Access Compliance Report

Public Rights-of-Way

(Pedestrian Signals)

Intersection ID: N/A	Main Street:	Cross Street: N/A	Location: N/A
ADA ID: CDC13FE5E434	Signal Type: One Push Button-Non APS	Overall Compliance: No	Severity Score: BTN 1: N/A BTN 2: N/A No BTN: N/A
Codes/Mitigation Info/Possible Solution		Field Measurements/Component Compliance

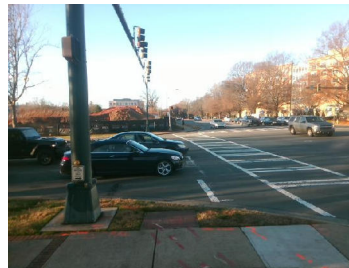
PROW/ADA: R209.1, TMUTCD 4e.08, R406.2, R404.7.3

Possible Solutions: Replace Signal Push Button With APS Button on New Post. Remove & Replace Sign.
